Date: September 23, 2016

From: Midland Manufacturing

**REASON FOR BULLETIN:** On December 2, 2015, the Chlorine Institute, with support from member organizations, issued a request to PHMSA to re-consider the use of screw plugs on tell-tale valves used with chlorine tank car pressure relief devices (PRDs).

**OPTIONS TO ENSURE COMPLIANCE FOR TANK CARS USING TELL-TALE VALVES WITH THREADED OUTLETS:**

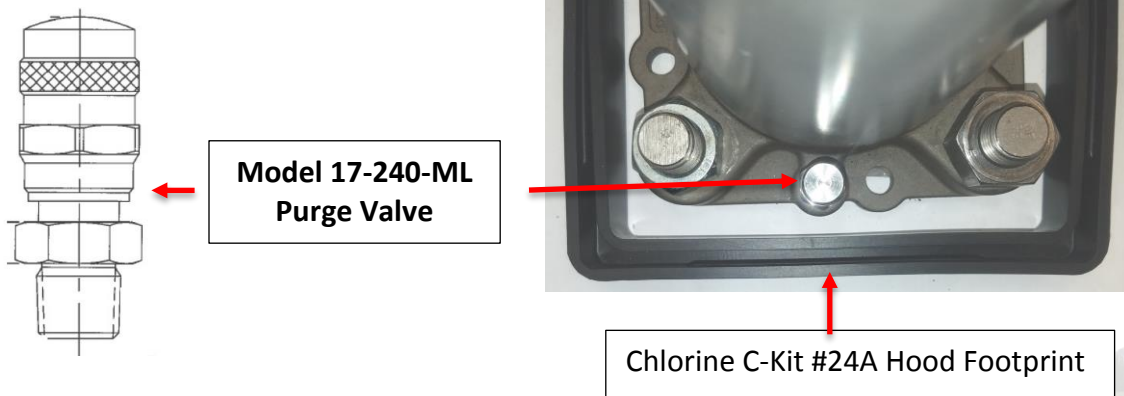
**In-Shop Repair Procedure**

Replace tell-tale valves with threaded outlets with Midland purge valve #17-240-ML.

Note: it is necessary to test the threaded connection between the purge valve and the PRD mounting flange. This process cannot be done in the field because the rupture disc must be removed from the PRD.

## In-Field or In-Shop Repair Procedure

Procedure to use tell-tale valves with threaded outlet and screw plug.

1. Install screw plug (Midland #18-ML). If the plug faces outward, away from the PRD it will extend into the footprint of the Chlorine Kit #24A hood. This interference will not be acceptable for emergency hazmat valve capping procedures. The needle valve with screw plug must be rotated towards the PRD.

Plug extends into the Chlorine C-Kit #24A Hood Footprint

2. Rotate the valve so that the screw plug will not extend beyond the footprint of the PRD. It is important to rotate the needle valve to ensure that the screw plug cannot interfere with the potential capping of the PRD.

3. The rotated needle valve must be tested for leaks at the threaded connection. Remove the plug and pressure test the connection at 30-55 psi for 2 minutes. When it is confirmed that no leaks are present, replace the plug to complete the process.
